Docket No. 50-220

Subject: FUEL DENSIFICATION

ORDER FOR MODIFICATION OF LICENSE

CHANGE NO. 9 TO TECHNICAL SPECIFICATIONS

FIGURE 3.1.7 MAXIMUM ALLOWABLE AVERAGE PLANAR LHGR APPLICABLE TO FUEL TYPE

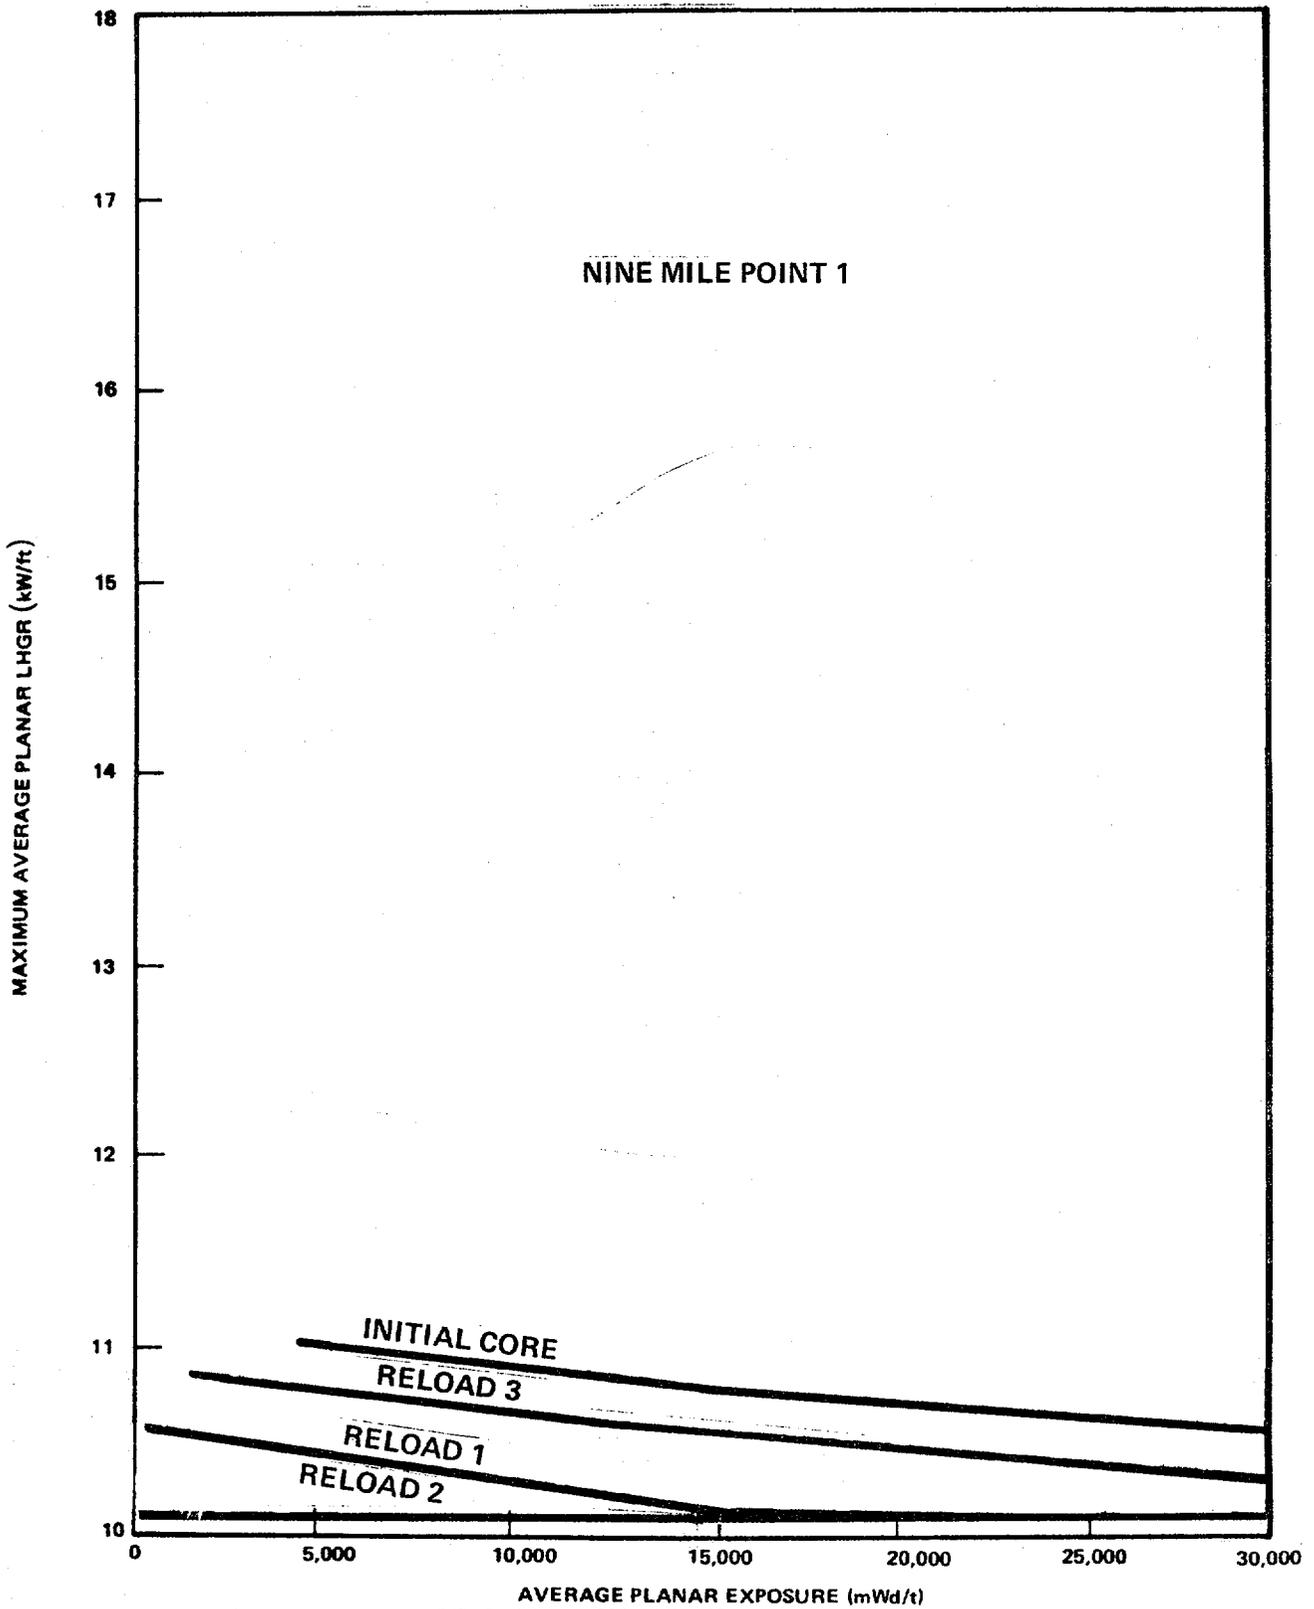
During steady state power operation, the average linear heat generation rate (LHGR) of all the rods in any fuel assembly, as a function of average planar exposure, at any axial location shall not exceed the maximum average planar LHGR shown in Figure 3.1.7.

The maximum average planar LHGR curves for the various fuel types in the core shown in Figure 3.1.7 are the same as those shown on the curves labeled " γ " (gamma) on Figures 4-9B1 through 4-9B4 of the GE topical report "Fuel Densification Effects on General Electric Boiling Water Reactor Fuel," NEDM-10735, Supplement 6, August 1973 and is the result of the calculations presented in Section 4.3.4 of the same report. These calculations were made to determine the effect of densification on peak clad temperature and were performed in accordance with the AEC Fuel Densification Model for BWRs which is attached to NEDM-10735, Supplement 6 as Appendix B.
